DESIGN & CONSTRUCTION MANUAL
DESIGN CRITERIA MODIFICATION REQUEST

PROJECT NAME: Trilogy Apartments _____

Re: Subsurface Exploration and Recommendations Addendum #1
Summit Square Phase III (Trilogy)
Lee's Summit, Missouri

Alternative Pavement Section

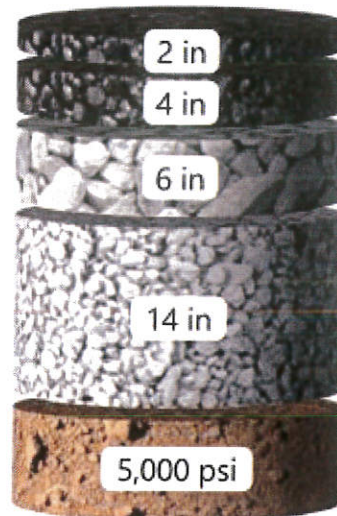
NorthPoint has requested a single alternative pavement design for both the heavy and light duty sections. CFS has estimated the layer coefficient for the soil-gravel mixture to be 0.05. This coefficient has been conservatively estimated as less than half of MoDOT Type 5 (0.120) and less than a fly ash stabilized sub-grade layer coefficient (0.080). The following table shows the layer coefficients for the alternative pavement.

Layer	Description	Layer Coefficient	Thickness (in)	Structural Number
ACC1	Asphalt Surface	0.400	2.0	0.80
ACC2	Asphalt Base	0.350	4.0	1.40
ABC	MoDOT Type 5	0.120	6.0	0.72
SBC	Rock Sub-Grade Mix	0.050	14.0	0.70
			Total	3.62

The recommended alternative section provides an estimated ESAL's and structural value of 411,100 and 3.62, respectively. This exceeds the larger heavy duty UDO estimated values.
